**Contractor Questions & Answers
For Solicitation No. SCO150-14-R-N012
Construction of CNP Base - PSIB at Bucaramanga
Santander– Colombia**

Following is the list of the questions received from the contractors participating in the above solicitation. Each question is followed by the Government's response.

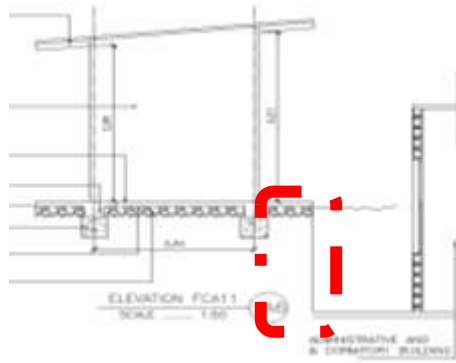
Question #19: There are NO details about fence. For the mesh: Caliber, size of the separation, height, etc.). For the posts: material, diameter, depth of foundation, type of foundation. Please provide details (Los planos no contienen especificaciones de la malla (calibre, tamaño del hueco, templates) ni de los postes (profundidad, cimentación, diámetro, calibre del material) Suministrar detalles.

Answer: The chain link fence shall be constructed using a 10 gauge (interior), (8 gauge exterior) wire mesh with a 2-Inch x 2-Inch opening, which shall meet the rule of 80 grams of galvanized/m2, and the galvanized percentage shall be certified in the offer. The post shall be galvanized steel with a diameter of 2-Inch. The steel plate that according to the drawing ties the wire mesh to the steel post shall be a 3/4-Inch plate.

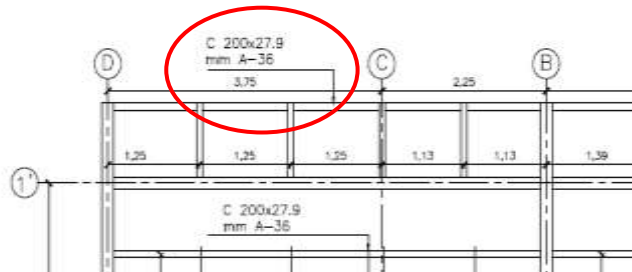
Question #23: Please clarify dimensions of the purlins for the roof metal structure. Profile C200x27.9 mm doesn't exist or isn't comercial available. (Aclarar las dimensiones del tipo de perfil a utilizar (C-200x27.9mm A-36). No es un perfil que exista de acuerdo a las cartillas comerciales)

Answer: The Structural designer confirmed that the profile specified should be is C200x27.9 mm and that it can be found as a commercial item by many providers in Bogota.
